From: WELLS Russell (AREVA) [Russell.Wells@areva.com]
Sent: Friday, July 22, 2011 1:01 PM
To: Tesfaye, Getachew
Cc: WILLIFORD Dennis (AREVA); ROMINE Judy (AREVA); BENNETT Kathy (AREVA); DELANO Karen (AREVA); RYAN Tom (AREVA)
Subject: Response to U.S. EPR Design Certification Application RAI No. 376, FSAR Ch. 3, Supplement 26 (Part 1 of 2)
Attachments: RAI 376 Supplement 26 Response US EPR DC - PUBLIC - Part 1 of 2.pdf

From: WILLIFORD Dennis (RS/NB)
Sent: Wednesday, July 20, 2011 10:27 AM
To: Tesfaye, Getachew
Cc: BENNETT Kathy (RS/NB); DELANO Karen (RS/NB); ROMINE Judy (RS/NB); RYAN Tom (RS/NB); Miernicki, Michael
Subject: Response to U.S. EPR Design Certification Application RAI No. 376, FSAR Ch. 3, Supplement 25 (Part 1 of 2)

U.S. EPR FSAR Tier 2, Sections 2.5.2, 3.7.1, 3.7.2, 3.8.4.4.2, 3.8.4.4.3, 3.8.5.1.2, 3.8.5.4.3, 3.8.5.5.2, Appendix 3E.2, Table 2.1-1, Table 3.8-19, Figure 3.8-93, and Figure 3.8-94 will be revised as described in the response and indicated on the enclosed markup.

Figure 3.7.1-33—Input Motion for Structures not on the Nuclear Island Common Basemat, Horizontal Motion
5% Damping (EUR)

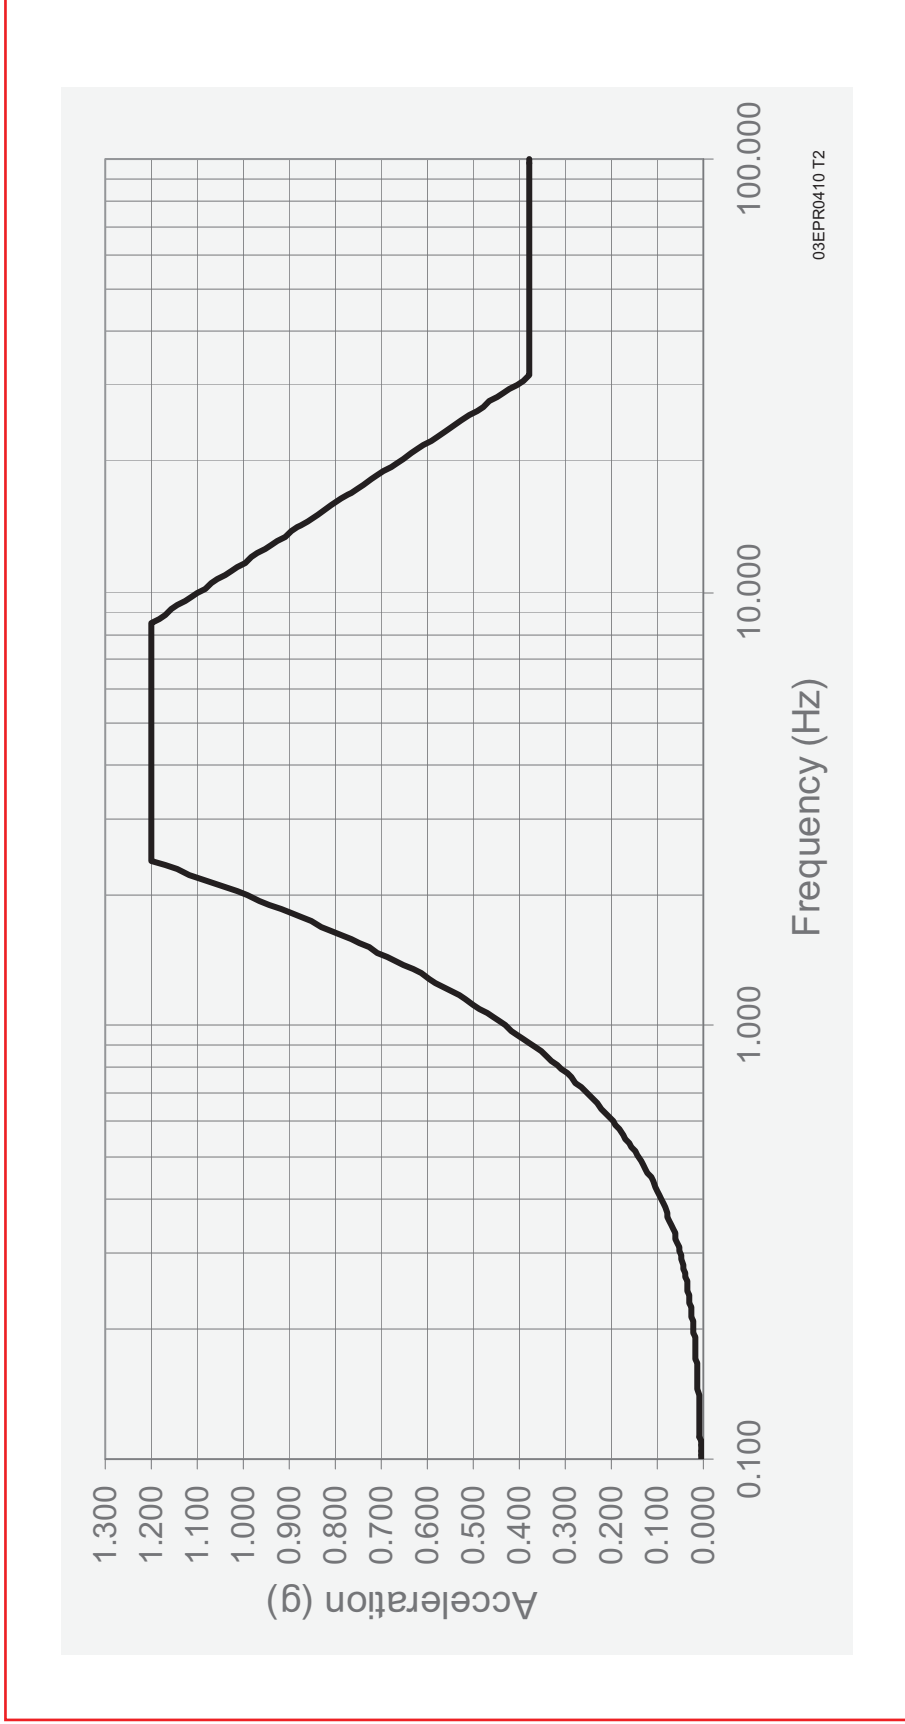
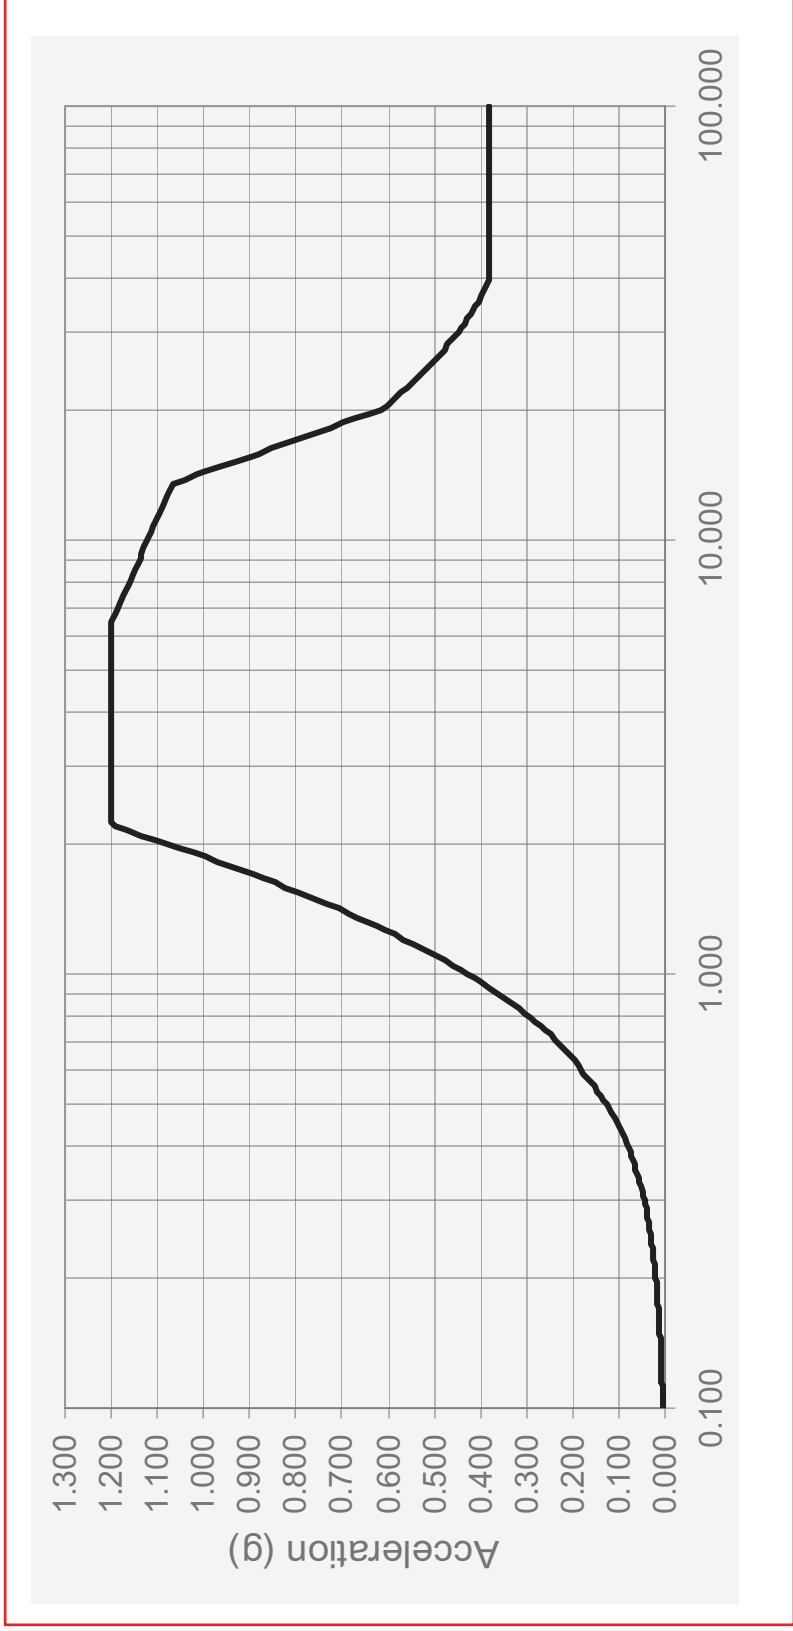
Figure 3.7.1-33—Input Motion for Structures not on the Nuclear Island Common Basemat, Horizontal Motion 5% Damping (EUR) and Figure 3.7.1-34—Input Motion for Structures not on the Nuclear Island Common Basemat, Vertical Motion 5% Damping (EUR); show the ~~modified~~ input motion obtained by modifying the EUR control motions, identified as SSSI motion, for the Seismic Category I Structures that are not on the NI Common Basemat, ~~and Section 3.7.2.4 describes the basis for the development of these spectra in more detail. This input motion does not constitute a second seismic design basis (i.e., a second set of CSDRS); rather it is the logical extension of the seismic design basis CSDRS to provide input motion to structures not on the common basemat.~~ Figure 3.7.1-49—Input Motion for Structures Not on the NI Common Basemat, Horizontal (SSSIHF) and Figure 3.7.1-50—Input Motion for Structures Not on the NI Common Basemat, Vertical (SSSIHF) show the high frequency input motion obtained by modifying the HF control motion, identified as SSSIHF motion, for the ESWB and EPGB. These input motions do not constitute an additional seismic design basis (i.e., a second set of CSDRS); they are the logical extension of the seismic design basis CSDRS that provide input motion to structures not on the common basemat.

Figure 3.7.1-41—Cumulative Energy Plot for Time Histories for Structures not on the Nuclear Island Common Basemat (EUR)

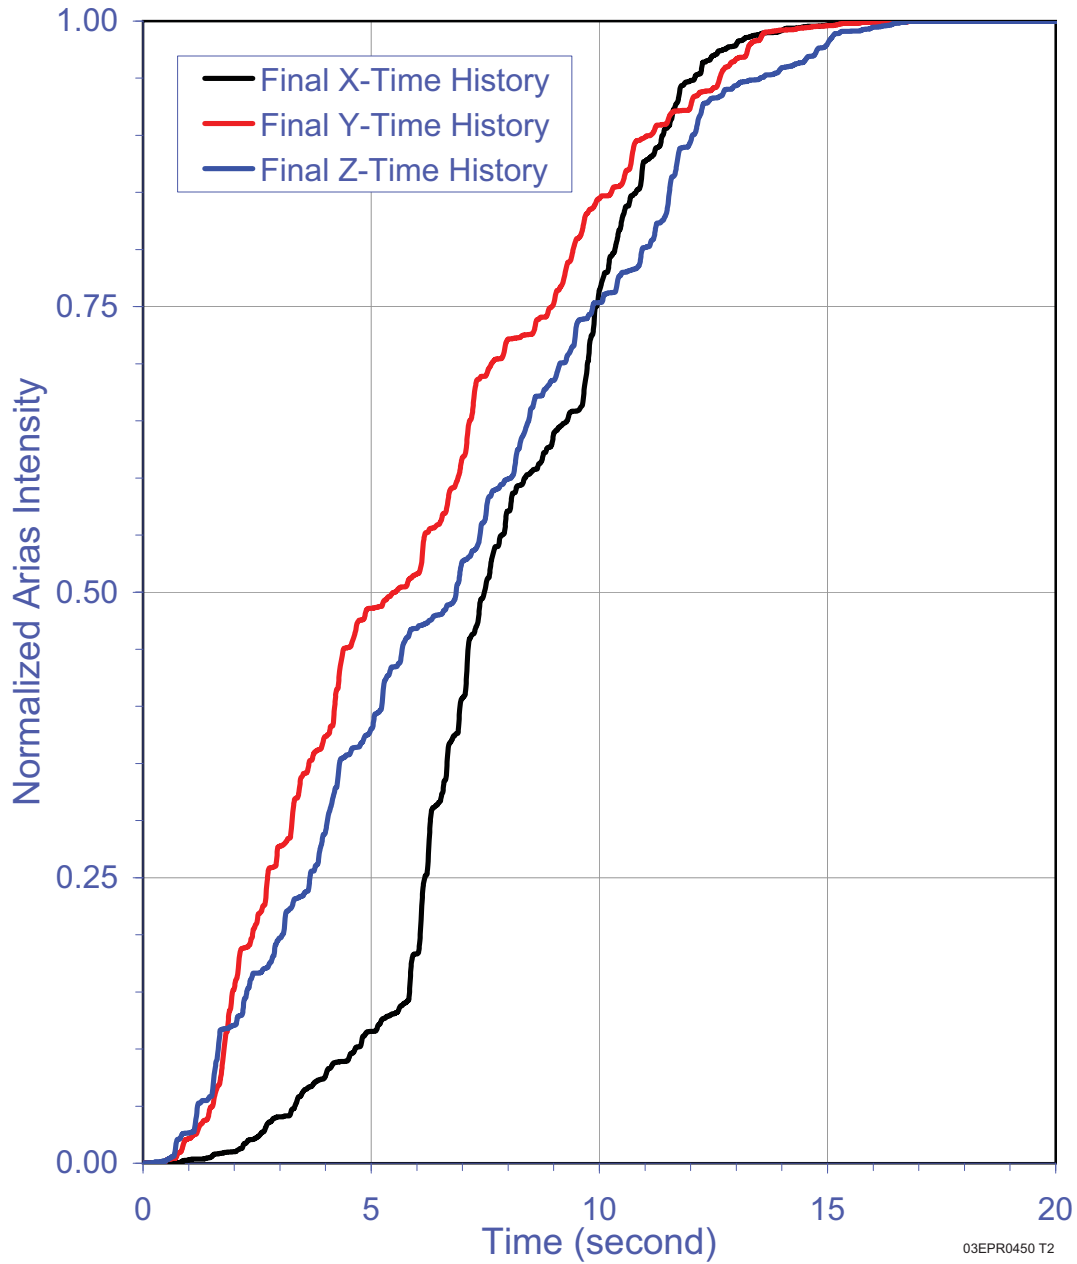
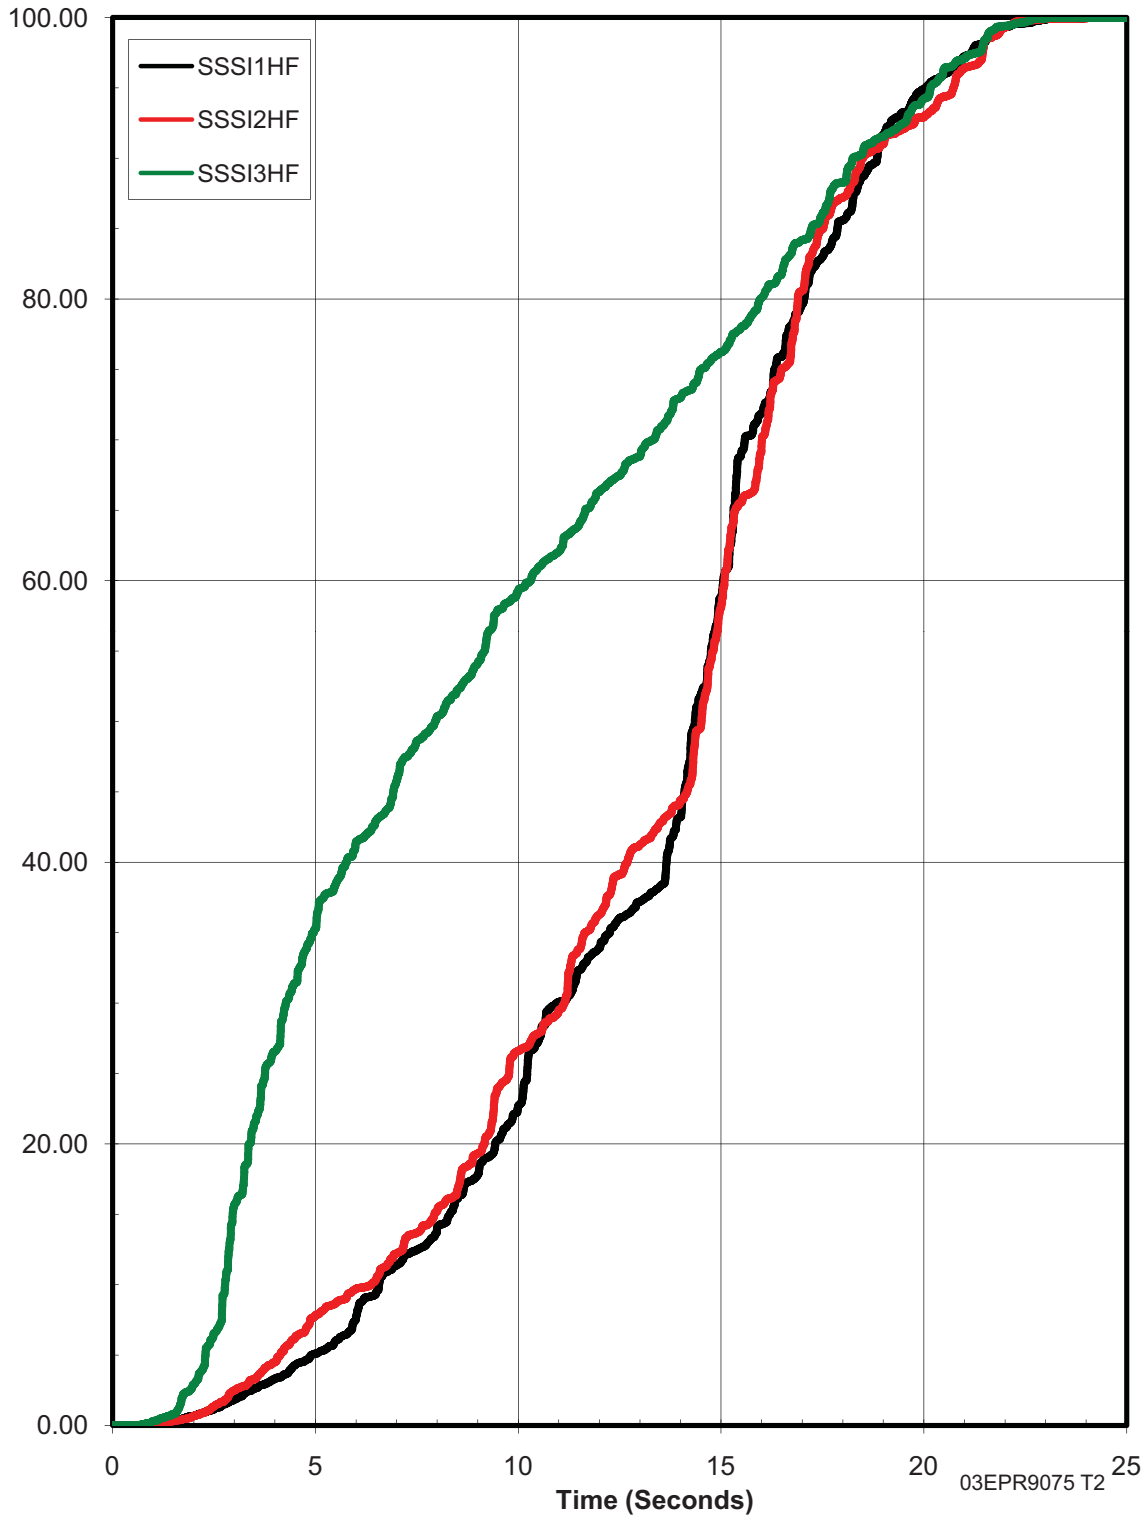
Figures 3.7.1-26 to 3.7.1-28, ~~and~~ Figure 3.7.1-41, Figure 3.7.1-48, and Figure 3.7.1-59 show the Arias intensity function (or Cumulative Energy function) and the strong motion duration of each synthetic time history in the five percent to 75 percent Arias intensity. The strong motion durations calculated for the EUR-HF, SSSI, and SSSIHF time histories are shown in Table 3.7.1-3—Strong Motion Duration of Synthetic Time Histories. The minimum strong motion duration is six seconds, which meets the guideline in SRP Section 3.7.1 (Reference 6).

Figure 3.7.1-60—U.S. EPR Standard Plant Soil Profiles - Shear Wave Velocity for EPGB and ESWB SSI Analysis Cases (EUR)

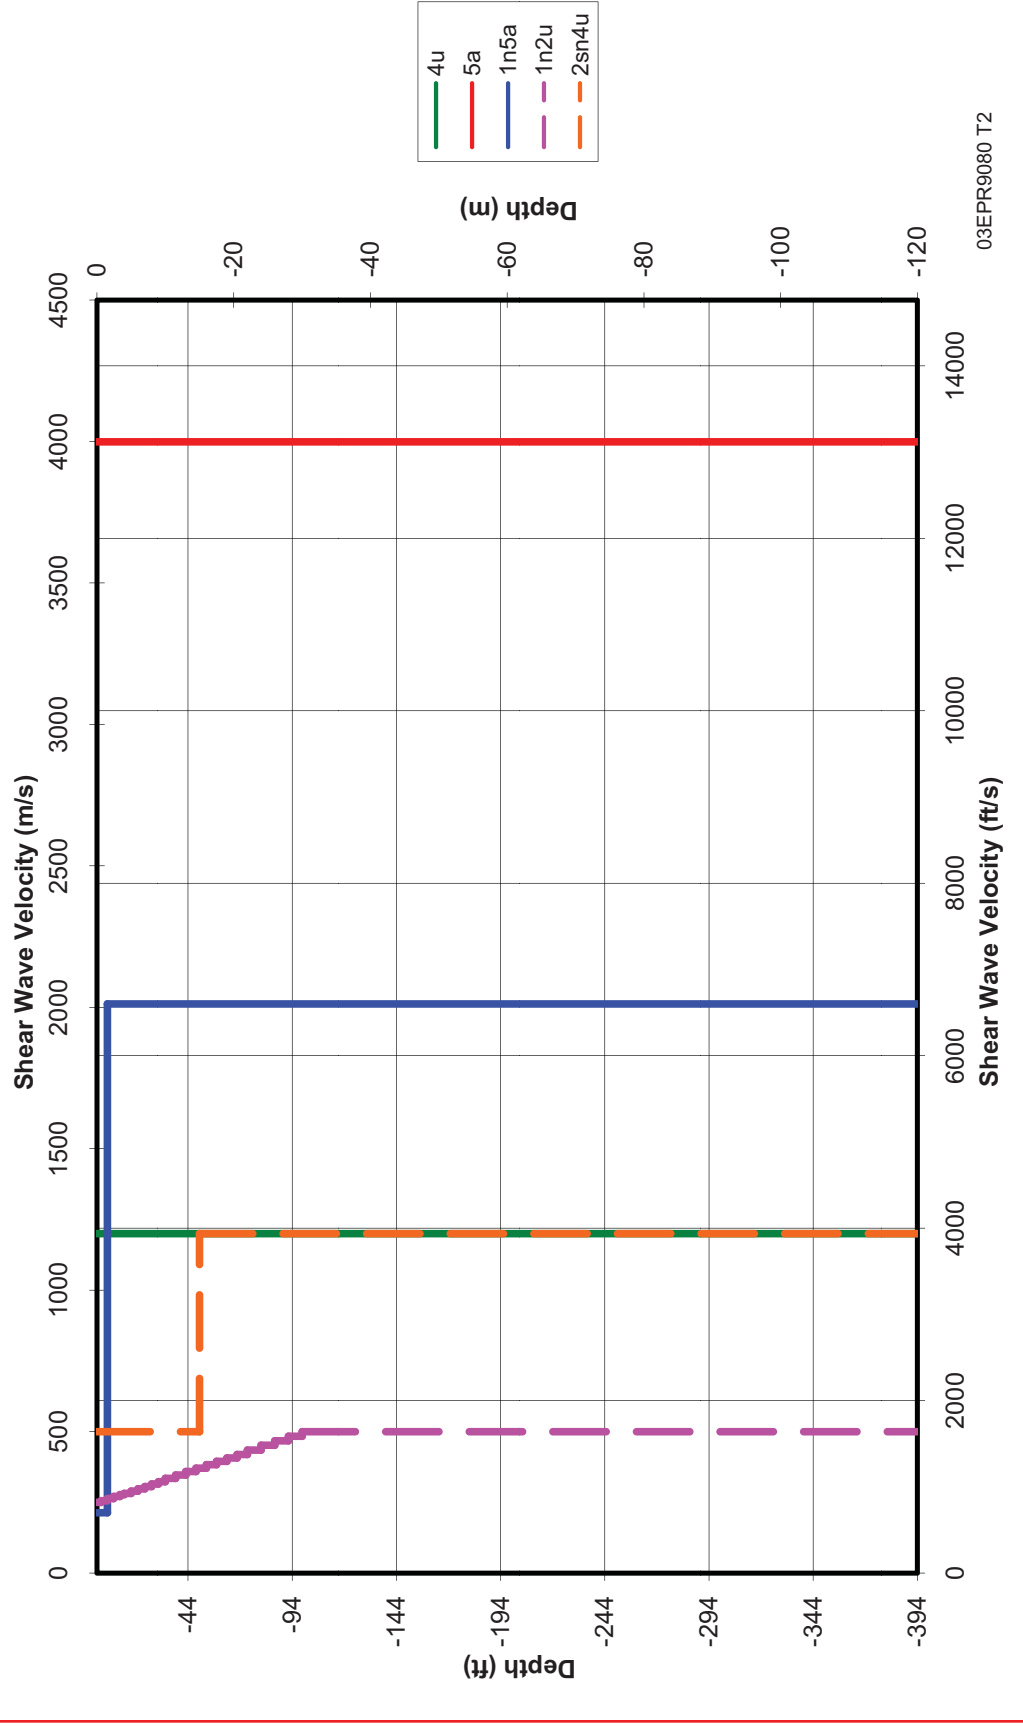
Responses to Items 1 through 5 apply to the Emergency Power Generating Building (EPGB). The Essential Service Water Building (ESWB) will be addressed in a supplemental response to this question. U.S. EPR FSAR Tier 2, Figure 3.7.1-60 shows EPGB and ESWB shear wave velocity profile, and the information will not change in the supplemental response addressing the ESWB.
